OUR TOWN HALL PROJECT

PROJECT STATUS	RIBA STAGE 4
CLIENT	MANCHESTER CITY COUNCIL
PROJECT	OUR TOWN HALL
DRAWING TITLE	S10 Lloyd street elevation and sections proposed
SIZE & SCALE	A1: As indicated
DRAWING STATUS	S4 for Construction
JOB NUMBER	236959
DRAWING NO.	OTH-PUR-EX-ZZ-DWG-A-4133
REV	02

S10 Elevation
1 : 20

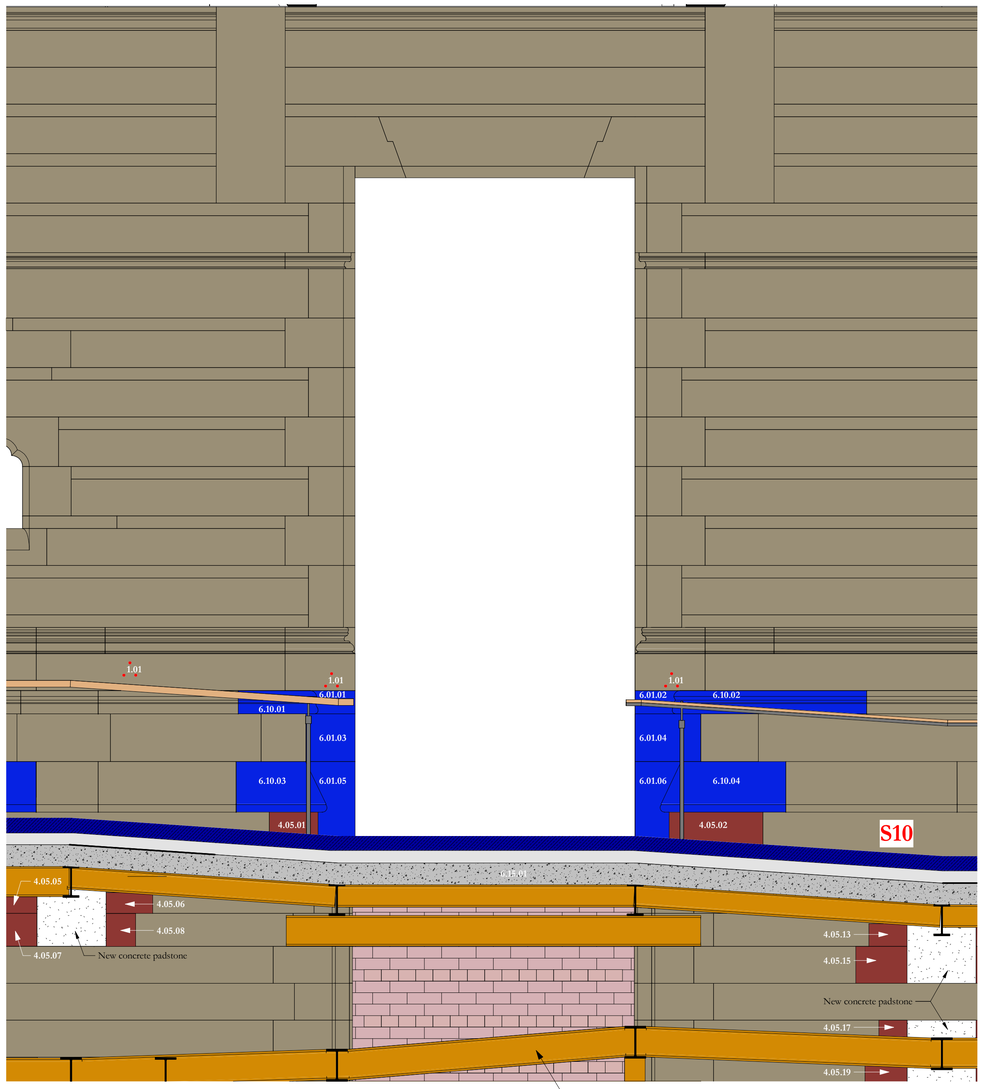
Revision 01:
Handrail and guard rail added to external ramp, steel structure and pad stone layout amended, opening infill detail shown with English Garden Wall bond

Revision 02:
Drawing issued for construction, key updated, all other information remains the same
